Comanche Peak Training Center
PWS #2130037
Comprehensive Compliance Investigation Findings Response
Track #419001

COMANCHE PEAK TRAINING CENTER
PWS #2130037

Alleged Violation:

FIGURE 1

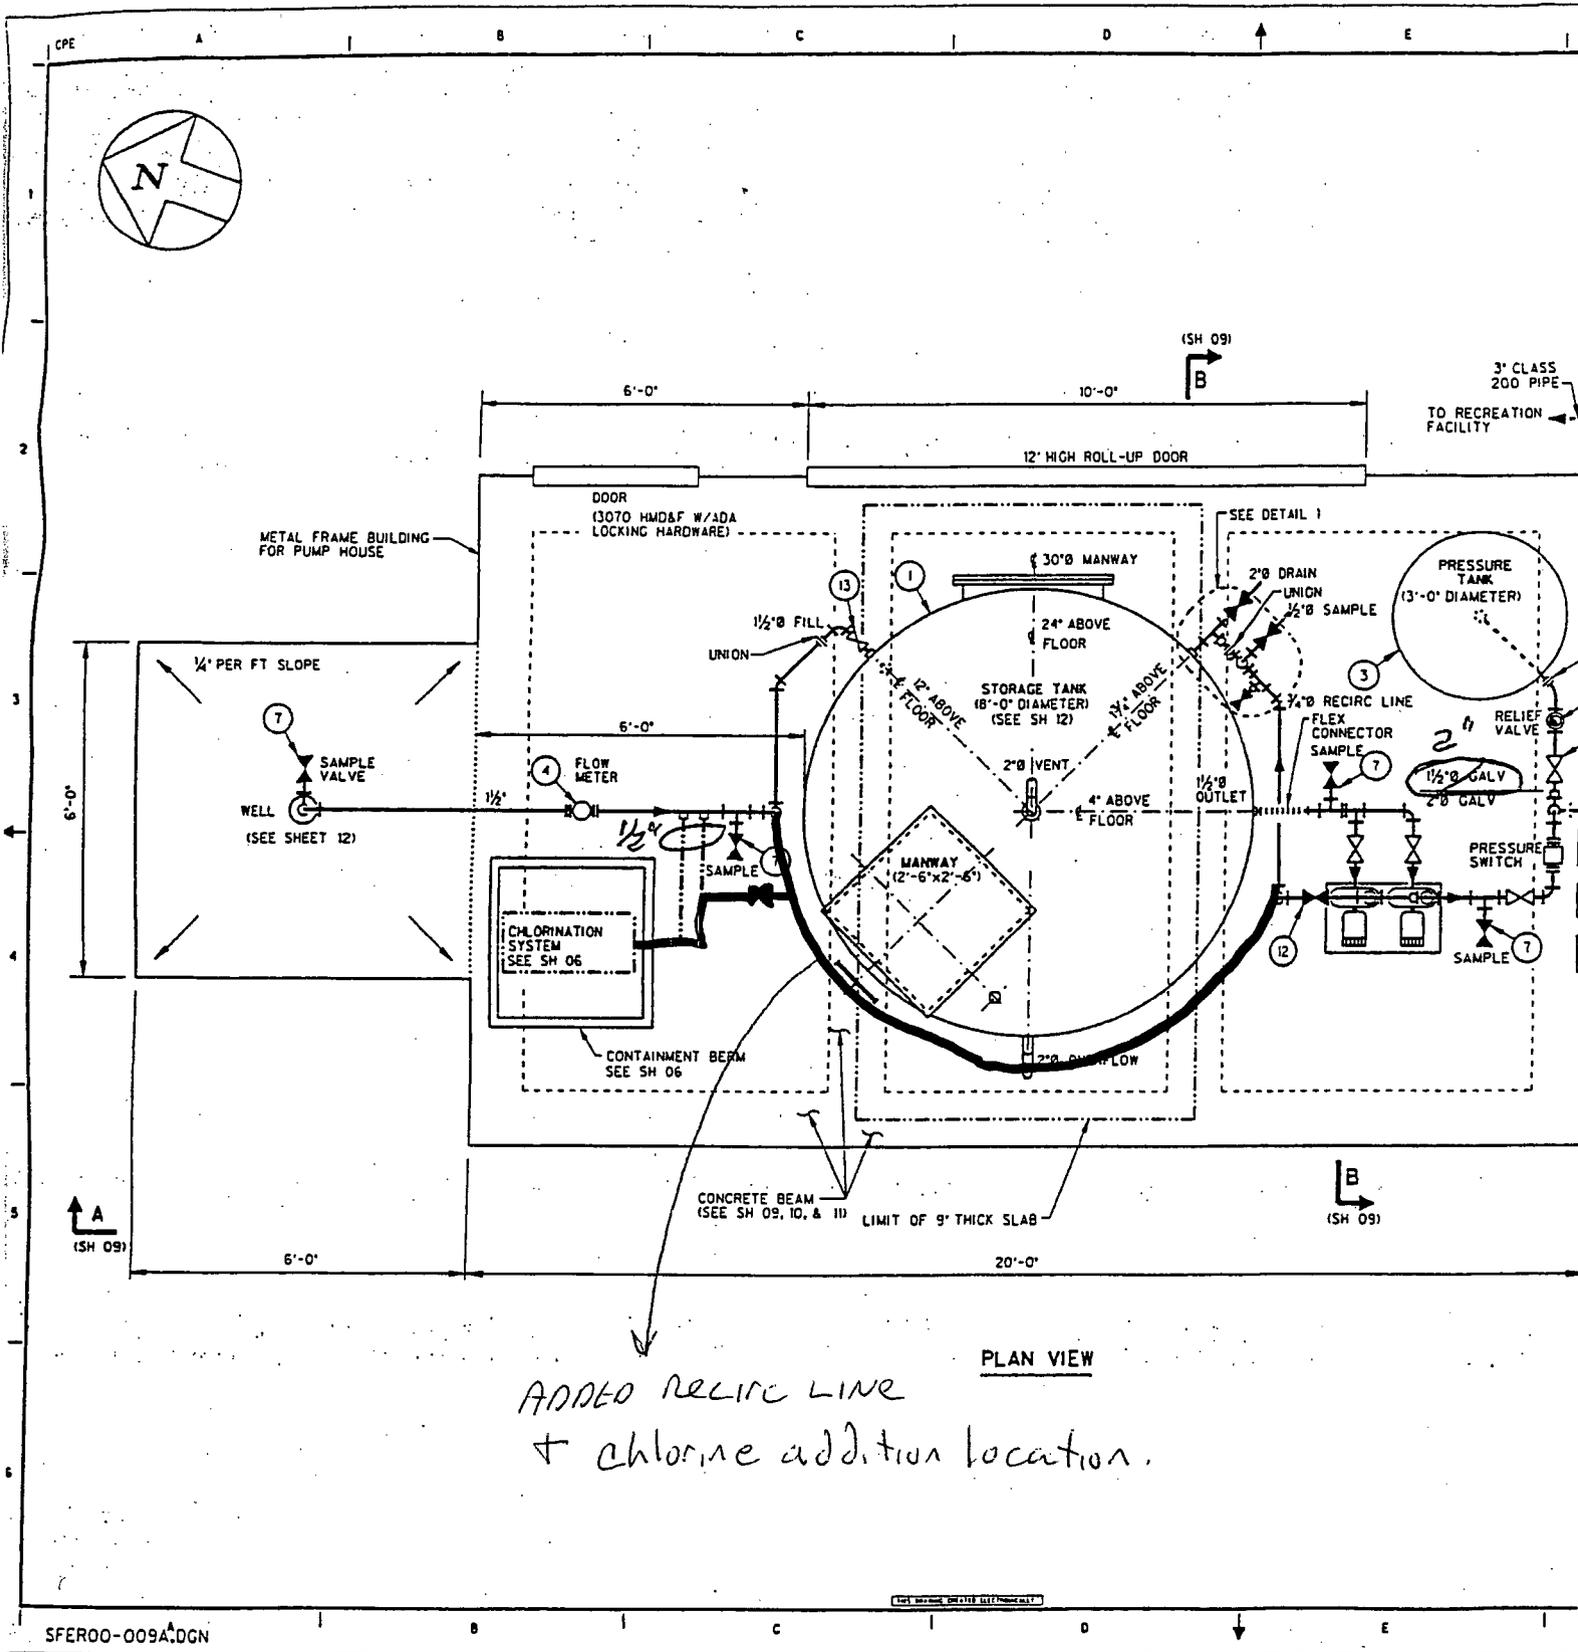
Failure to hypochlorinate prior to the potable water storage tank in accordance with 30 TAC 290.42(e)(2).

Due to the potentially extended residence time in the system's potable storage tank, simple chlorination of raw water when the tank is filled by the operation of the well is not sufficient to assure maintenance of a chlorine residual in the tank, and thus, in the distribution system. Historically, the chlorine residual has been maintained through manually-initiated recirculation. At the time of the addition of the recirculation line, the hypochlorite feed piping was removed from the inlet piping and connected to the recirculation piping as shown in the attached figure.

Since prior experience at start-up of the system has proven that direct hypochlorination of the well pump discharge only is inadequate to maintain a residual in the storage tank, it is imperative that the capacity to inject hypochlorite into the tank recirculation system be maintained. Therefore, the modification implemented maintains the same injection point in the recirculation piping, but provides for automated hypochlorination of raw water passing through this piping.

The recirculation piping is now being left valved in-line with the tank inlet. This valve alignment allows for a free flow of well water to flow to both the tank inlet point as well as to the opposite side of the tank via the recirculation piping. The hypochlorite pump is now controlled through an electrical outlet which is energized at the same time as the well pump when it receives the tank low level signal. Leaving the hypochlorite pump in the "RUN" setting, will result in hypochlorite injection whenever the pump's electrical supply is energized. This results in hypochlorite feed to raw well water prior to the storage tank. With well water entering the tank at two points, some of the raw water will enter the tank unchlorinated, but the tank will always be simultaneously receiving chlorinated water from the other inlet point. Manual recirculation hypochlorination continues to be performed as needed as it was prior to this alignment.

NOTE: In this alignment, the service pumps are isolated from the recirculation piping to eliminate any potential distribution pressure drops that might occur when the service pumps are operating. By maintaining this alignment, the discharge from the service pumps will be confined to the pressure tank and distribution and there will be no pressure loss due to a discharge back to the storage tank.

The attached photos, and drawing, (figure 1), show the recirc line where the chlorine is added to the system. The flow from the well is split and goes both directions through the recirc line adding chlorine when the well is pumping. A receptacle on the wall was discovered to be wired to start the chlorine addition pump when the well is running, and injecting chlorine as required. The connection of the chlorine pump to the recirc line, instead of the line from the well is superior, because it also allows for addition of chlorine when the well is not operating, by allowing the use of a recirc pump and recirc configuration. Since the well will sometimes go nearly a month without adding water to the tank, this ability to add chlorine when the well is not pumping is critical to maintaining adequate chlorine residual.
